PLANNED UNIT DEVELOPMENT & SURDIVISION STAFF REPORT

DEVELOPMENT NAME Nephrology Associates

SUBDIVISION NAME Nephrology Subdivision

LOCATION 1551 Old Shell Road

SITE PLAN

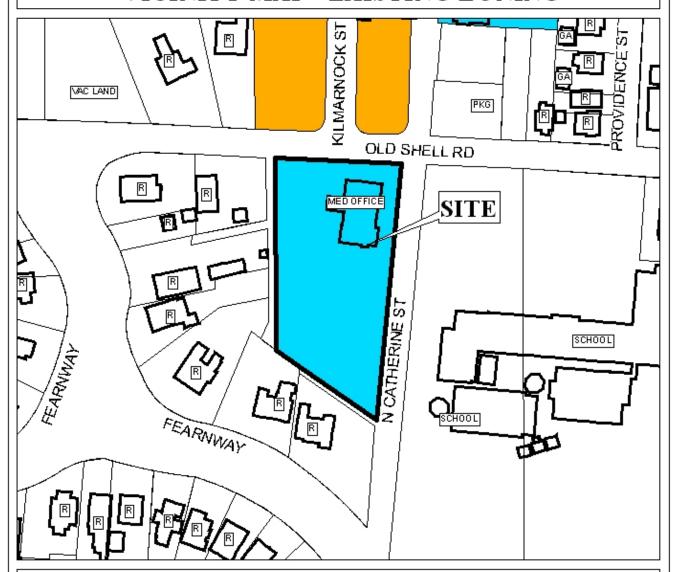
<u>COMMENTS</u> Driveway number, size, location and design to be approved by Traffic Engineering and conform to AASHTO standards. Parking aisles are illustrated in assumed vicinity of ADA parking for new building, but actual spaces are not designated. Additional ADA parking requirements may be applicable for the existing building. Sidewalk,

either existing or proposed, is not illustrated along Catherine Street adjacent to the proposed Lot 2 and should be included in the site plan.

The proposed lots, as depicted, meet the minimum size and frontage requirements as regulated by the Subdivision Regulations. The 25-foot minimum building setback line is depicted, and this should be retained on the Final Plat, if approved. The lot area sizes are not depicted on the plat, and these should be shown, in square feet, on the Final Plat, if approved.

The site currently has two curb cuts, one to Old Shell Road and one to North Catherine Street. The proposed site plan depicts the existing curb cuts remaining, with a new, additional curb cut on North Catherine Street south of the existing one. The site, with the approved PUD, will essentially function as a single building site. Given the 467.64 linear feet of frontage along North Catherine Street, an additional curb cub would not seem to be an issue. As such, a note should be placed on the Final Plat, if approved, stating that Lot 1 is limited to one curb cut to Old Shell Road and one curb cut to North Catherine Street and Lot 2 is limited to one curb cut to North Catherine Street with the size, design, and exact location of all curb cuts to be approved by Traffic Engineering and conform to AASHTO standards. It should be noted that the existing curb cut at Old Shell Road is les than 24 feet in width, and should be widened to the standard 24 feet.

The site abuts properties zoned R-1, Single-Family Residential, to the West and South. The site plan does not depict an adequate buffer, and a buffer compliant with Section 64-4.D.1. of the Zoning Ordinance. Further, a note should be placed on the Final Plat, if approved, stating that any lots which are developed commercially and adjoin residentially developed property must provide a buffer, in compliance with Section V.A.8. of the Subdivision Regulations

Sidewalks are depicted for Lot 1, however no sidewalks are depicted for Lot 2. A city standard sidewalk should be shown along all public rights-of-way, or request a sidewalk waiver from the Planning Commission.

The site plan does not depict landscaping area or tree plantings. Full compliance with both landscaping area and tree plantings will be required.

- 1) depiction of any required dedications and minimum building setback line on the site plan;
- 2) depiction of a buffer compliant with Section 64-4.D.1. of the Zoning Ordinance wherever the site abuts residentially zoned property;

- 3) compliance with landscaping and tree planting requirements of the Zoning Ordinance;
- 4) depiction of a city standard sidewalk along all public rights-of-way, or request a sidewalk waiver from the Planning Commission;

- 5) widening of the existing curb cut on Old Shell Road to 24 feet;
- 6) placement of a note on the Final Plat stating that development of the site must be undertaken in compliance with all local, state and Federal regulations regarding endangered, threatened or otherwise protected species;

- 9) provision of two copies of the revised site plan incorporating the above conditions to the Planning Section of Urban Development prior to any land disturbance activities.
